## NAFFCO FIRE RATED DUCTWORK SYSTEM

### Fire Rated Ductwork Installation Inspection Report

**Project Name** : G+4P+19 Floors + Roof  
**Project Number** : FRD-10015      **Order No** : DD/GID-10875-2023  
**Client/Customer** : Raneen  
**Main Contractor** :  
**MEP Contractor** : Raneen  
**Drawing No** : N/A      **Inspection No.** : 2  
**Installation Completion** : No      **Model Number** : NFRD 1000 VS (E2)  
**FRD location** : Level - 01      **Date** : 16 Feb 2024

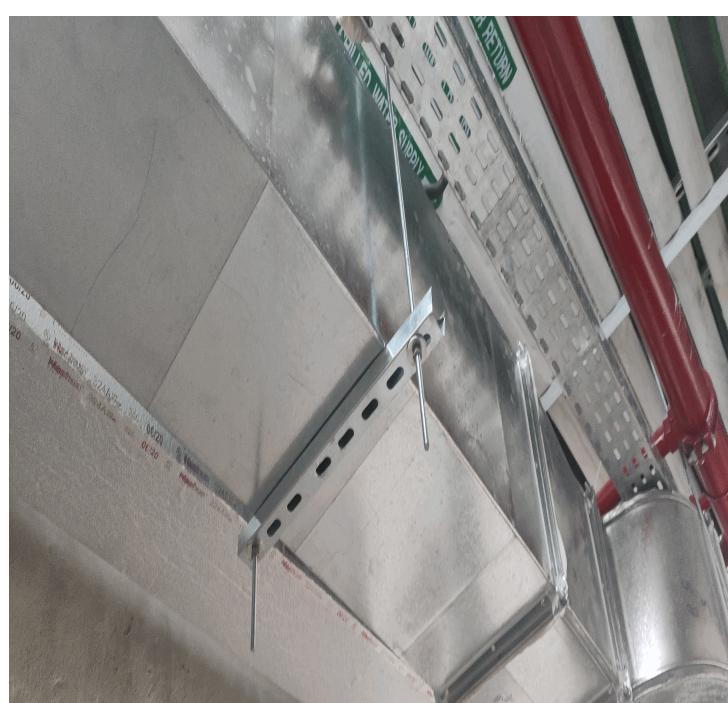
SLNO	CHECK LIST	YES/NO	COMMENT	ACTION REQUIRED
1	Has the NAFFCO supplied gasket been used between Duct flanges properly?	Yes		
2	Has the G-Clamp been fixed on joints at specified distance?	No	G Clamps found installed at the pitch which is less than prescribed.	Need to install the missing G Clamps at the pitch of 200mm.
3	Are the hanger rod & bearer support complying with NAFFCO Hanger-Support Table	No	Inside corridor at level - 02 hanger rods of size M8 found installed which is not acceptable.	Need to replace all hanger rods with M10.
4	Are the support distance as per the Hanger-Support given in Installation Instruction?	No	Support distance found to be more than specified.	Need to adjust the gap between supports as per provided NAFFCO INSTALLATION INSTRUCTION
5	Are drop rods within 50mm of duct side surface?	Yes
